**ADDENDUM NO. 5
FACILITY UPGRADE PROJECT
Bid File 3839**

RFI QUESTIONS AND ANSWERS.

FAX FACILITY IMPROVEMENT PROJECT

ED-100
SCALE: 1/32" = 1'-0"
0 16 32 64 96
1 inch plotted Feet

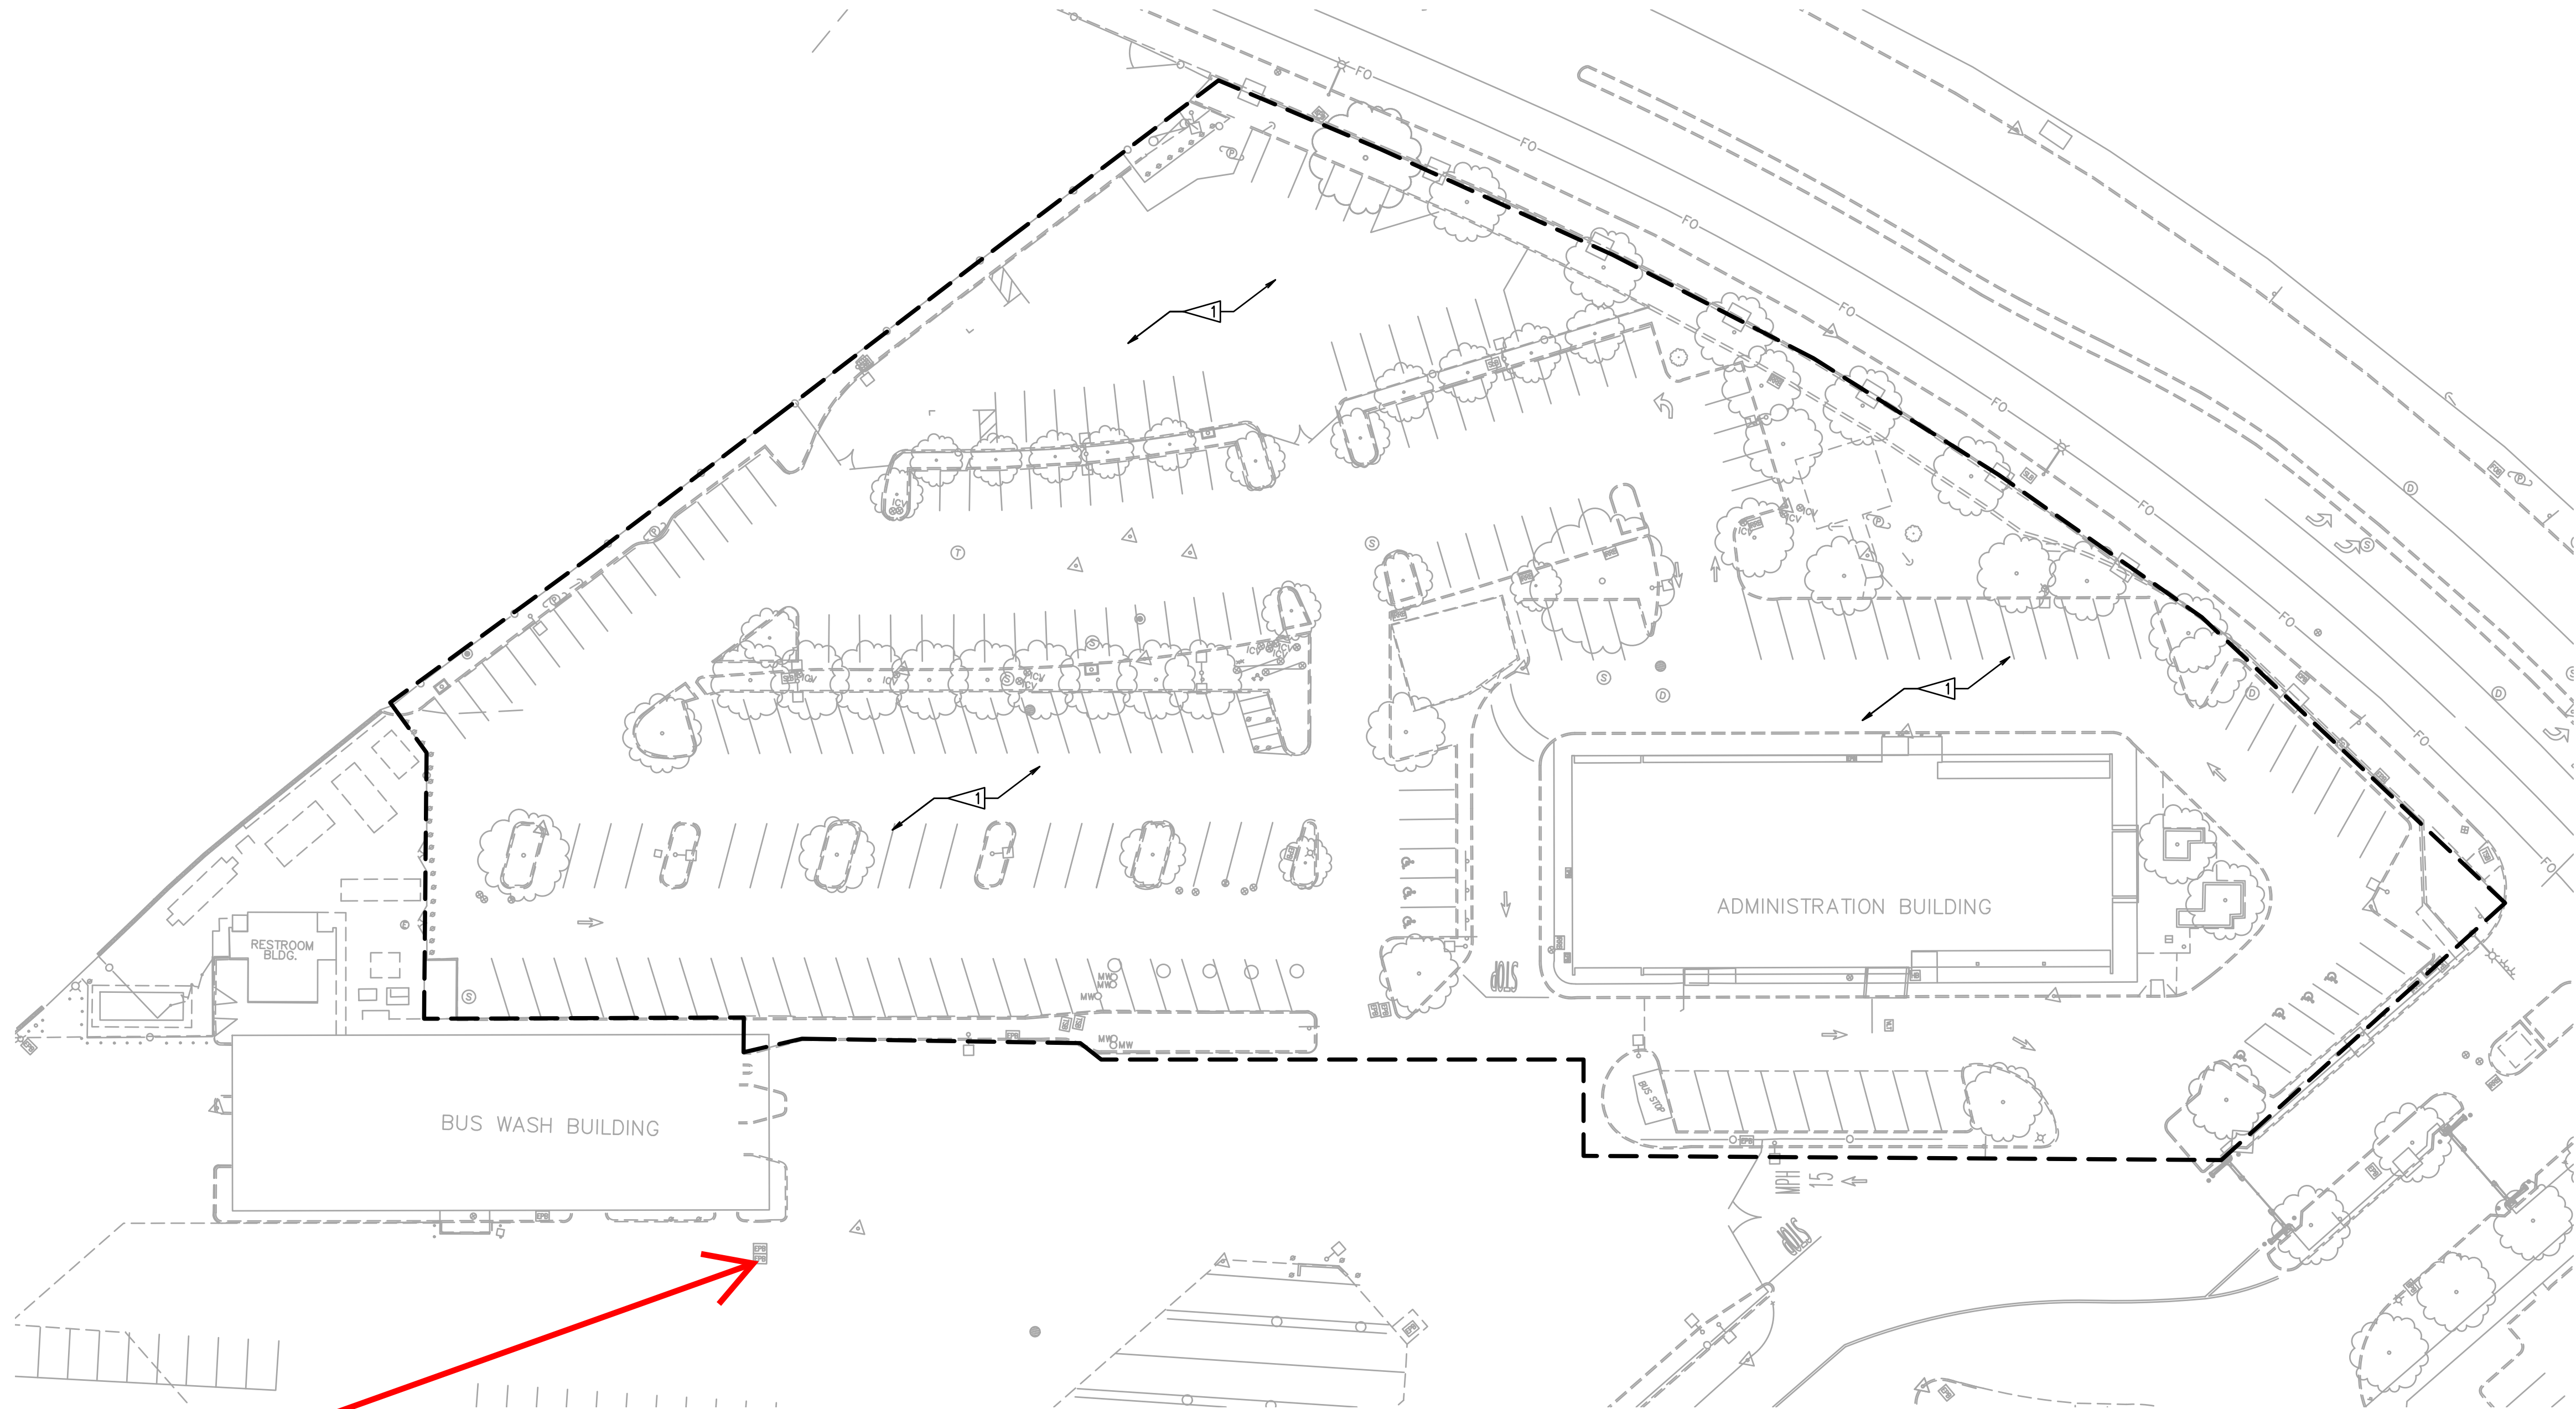
10. Sheet E-002 (1-line diagram) shows 2 feeders that we are to run into an existing pull box to feed the existing administration building. The pull box is not indicated anywhere on the drawings so we do not know how to route the new feeders. Can we get a location for these pull boxes?

Existing
Pull boxes

Answer: Refer to included drawing ED-100 and as-built drawing E-1 from 1981 for location of pull boxes.
